# Access Compliance Report

## Public Rights-of-Way

Intersection ID: 6634	Main Street: ABERGLEN_DR	Cross Street: DOVERHILL_PL	Location: SE
ADA ID: 412D5B06B9F0	Ramp Type: PerpDiag	Initial Pass/Fail: Fail	Overall Compliance: No
Severity Score: 8.75			
Codes/Mitigation Info/Possible Solution		Field Measurements/Component Compliance

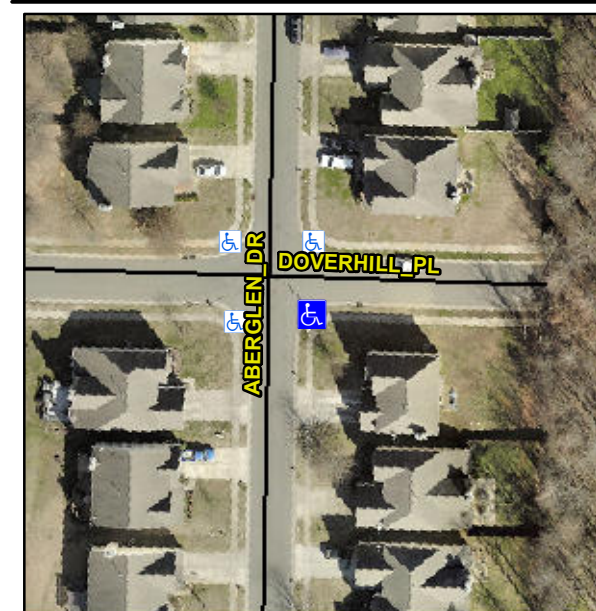
**Not Found, R304.5.1**

**Remove & Replace Curb Ramp With Two New Directional Ramps or Equivalent.**
